Re: Contract No. 200-2004-03805, Task Order 1: Draft Report SC&A-TR-TASK1-0019,  
Revision 1, *Pantex Plant Site Profile Review*

*Pantex Plant Site Profile Review*

**Contract No. 200-2004-03805  
Task Order No. 1  
SCA-TR-TASK1-0019, Revision 1**

**EXHIBIT 1**  
(Source: DOE 1996)

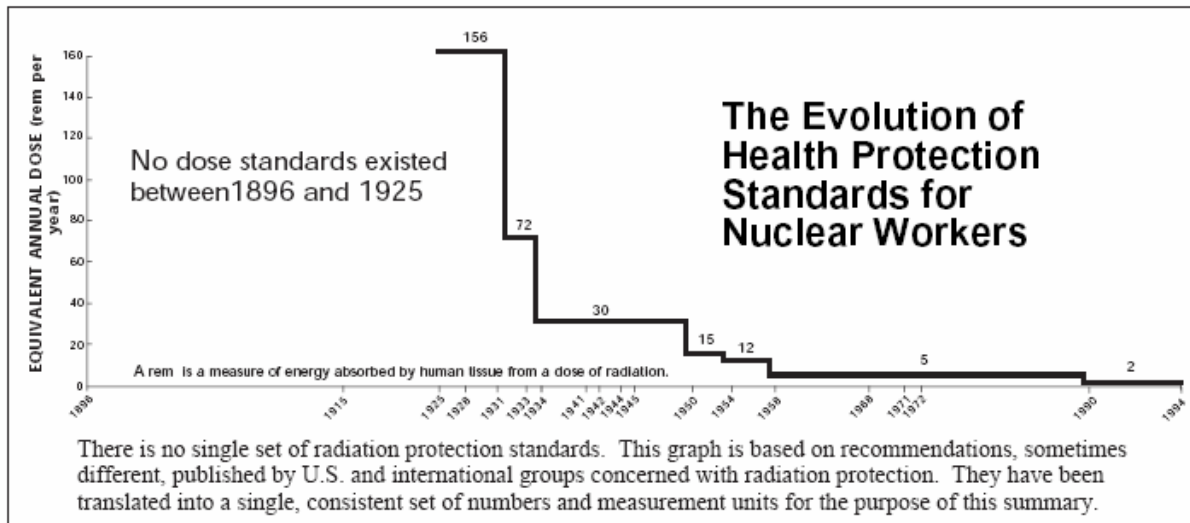
This indicates that Pantex based its 10% limit on the criterion of 3 rem per 13 weeks rather than the criterion of 5 rem per year. It is important to note that the referenced RPG of 5 rem per year was not fully implemented until 1968 (see Exhibit 1).
